FIELD SERVICE CAMPAIGN BULLETIN

Subject: **Field Service Campaign 17M2-REV**
GHG17 Heavy Duty Engine Platform Front Engine Lifter Bracket

Figure 1 – Front Lifter Bracket Part Identification

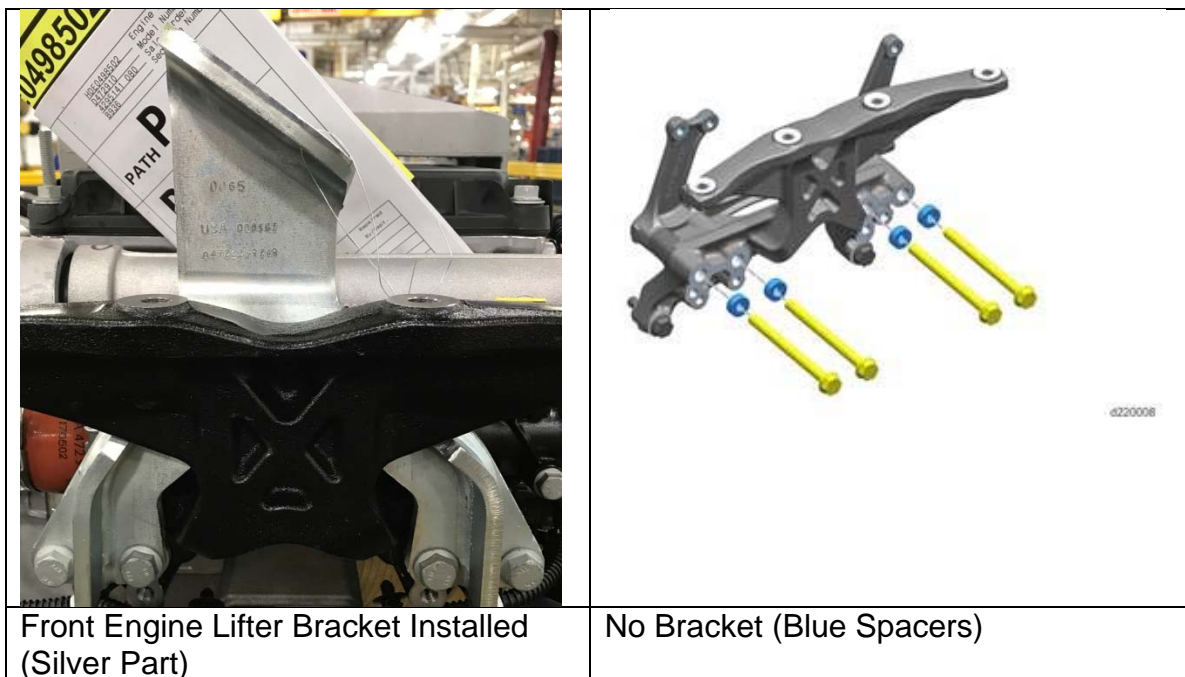
1. Apply the parking brake, chock the wheels, and perform any other applicable safety steps.
2. See Figure 1 for examples of an installed front engine lifter bracket or no bracket (spacers). Does the engine have a currently installed front engine lifter bracket?
 - a. If Yes, go to step 3.
 - b. If No, go to step 4.

The necessary part for this Field Service Campaign is lifter bracket P/N: A4722231241. Use only **ONE** bracket per vehicle.
